# **FINDLAY CITY PLANNING COMMISSION**

## **STAFF REPORT January 9, 2014**

1. **SITE PLAN APPLICATION #SP-01-2014** filed by Hancock County Performing Arts Center, 101 W. Sandusky Street, Suite 207, Findlay, OH for a performing arts center to be located at 200 W. Main Cross Street, Findlay, OH.

MARATHON CENTER FOR THE PERFORMING ARTS  
 PROPOSED RENOVATION AND ADDITION FOR THE  
 200 WEST MAIN CROSS STREET  
 FINDLAY, OHIO

**C2.0**  
 SHEET NO. 09101

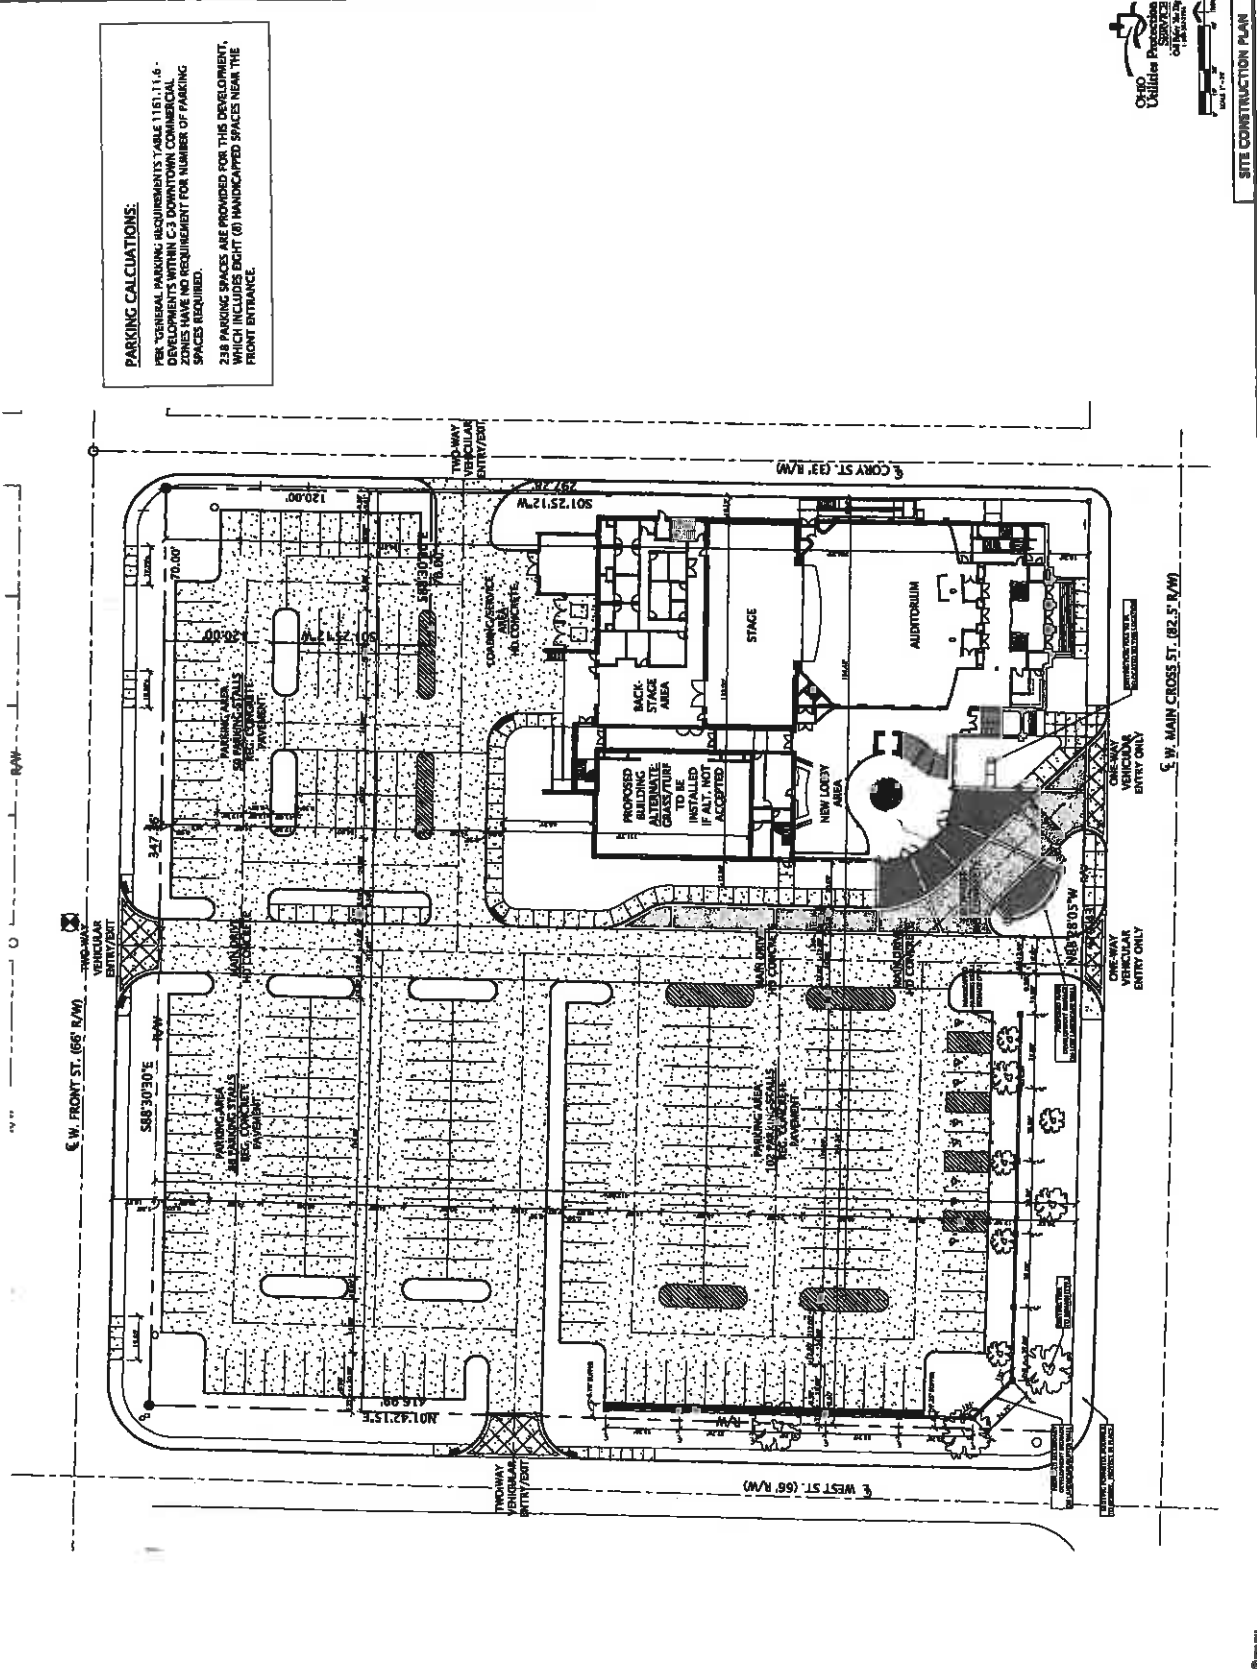
While the former school building had no access points onto W. Main Cross Street, the applicant is proposing two one-way entry only accesses for the lobby entry and parking lot. An angled entry point will allow for drop off at the lobby entry doors. This area is wide enough for two lanes. It also extends in a single lane along the sidewalk abutting the west side of the building giving the potential for cars to pull ahead and drop off along the walkway. Immediately west of that entry will be a straight in drive to the parking lot. We can see potential for on-site conflict of traffic for those coming out of the drop off lane into the main parking lot drive area. Yield signage may be required as a reminder. There is one ingress/egress point on each of the other streets abutting the site.

The layout has 238 parking spaces shown on the plan. The C-3 District has no required parking. Council adopted a new landscaping plan for Downtown parking lots in December, 2013. The ordinance requires decorative wall and landscaping for parking lots along Main Street and Main Cross Street. The site plan shows the required masonry/fence combination along W. Main Cross Street and continuing around the corner along S. West Street to the entry point into the parking lot. Decorative signage is shown to be located on the wall at the corner of Main Cross and S. West Street as permitted. Abundant landscaping is indicated along the Main Cross Street frontage with evergreens provided the rest of the way down S. West, Front Street and Cory Street. Island bump outs are indicated in the parking lot along the north half of the property. These are provided with landscaping as well. The parking lot in the southwest corner of the site has no bump out islands only striping. This area is left open to be used as a potential outdoor venue.

The lighting plan submitted shows 0 foot-candles at any property lines abutting residential uses. The maximum limit is .5 foot-candles. There are some relatively high counts at the access point at S. Cory Street, anywhere from 1.1 to 1.3 foot-candles on the east side of the street. The code maximum along non-residential is 1.0 foot-candle. This area would abut the back of the Library and a County owned building.

The main identification signage for the site is shown to be located on a low wall in the island between the two entry points on W. Main Cross. The details will have to be submitted to Todd Richard for approval and separate permit. There may be some interior directional signage needed and Mr. Richard had mentioned that he would sit down with the applicants and work out the details on this issue. There is mention of an "electronic marquee" on the east side of the building in the elevation drawings. There is no detail about what this may look like, but we would encourage that the applicants meet with Mr. Richard to discuss this item as well.

**Water:** The 8" waterline extension on Cory Street should extend to Front Street to provide a redundant supply to both fire and domestic service. The City does not permit 3" taps. The domestic tap should be 4", and reduced after the valve if desired. Valves on both fire and domestic services shall be provided. The City is examining the condition of the waterline on Front Street and may coordinate with the Owner to replace all or part of the section that abuts the project. Owner to coordinate waterline replacement with the City prior to plan finalization.

**Sanitary:** The existing sanitary lateral is a permitted connection point. Consultant to review City records for existing utilities. There are existing force mains on Front Street that do not show on the utility plan.

**Storm Sewer:** Storm sewer connection points are adequate. Consultant to confirm labeling of combined sewers to ensure no further connections are made to a sanitary sewer.

Access: Access to the site is adequate. There is a potential conflict point at the point where the Main Cross access drives converge. Walks/Ramps should be redone at the intersections to comply with latest ADA standards.

- Recommend to extend the proposed 8” Cory St. water line north to W. Front St. providing a looped system.
- A Knox Box will be required for buildings with alarm and sprinkler systems.
- Natural gas or electric meters within the driving area shall have crash protection.
- The Fire Department Connection (FDC) shall be 5 inch Stortz fitting with 30 degree angled elbow. Outside notification shall be a horn/strobe working on water flow only and placed above the FDC. Area in front of FDC shall be kept clear. FFD has no objection to the proposed FDC location. An additional location could be considered on the north (rear) of the building, as long as it does not interfere with utilities. Final location shall be approved by FFD.

- The 8” waterline extension on Cory Street should extend to Front Street to provide a redundant supply to both fire and domestic service. The City does not permit 3” taps. The domestic tap should be 4”, and reduced after the valve if desired. Valves on both fire and domestic services shall be provided. The City is examining the condition of the waterline on Front Street and may coordinate with the Owner to replace all or part of the section that abuts the project. Owner to coordinate waterline replacement with the City prior to plan finalization. (ENG & FIRE)

- Walks/Ramps should be redone at the intersections to comply with latest ADA standards. (ENG)
- A Knox Box will be required for buildings with alarm and sprinkler systems. (FIRE)

- Natural gas or electric meters within the driving area shall have crash protection. (FIRE)
- The Fire Department Connection (FDC) shall be 5 inch Stortz fitting with 30 degree angled elbow. Outside notification shall be a horn/strobe working on water flow only and placed above the FDC. Area in front of FDC shall be kept clear. FFD has no objection to the proposed FDC location. An additional location could be considered on the north (rear) of the building, as long as it does not interfere with utilities. Final location shall be approved by FFD. (FIRE)

- Review and approval of all signage by the City Zoning Department (HRPC)
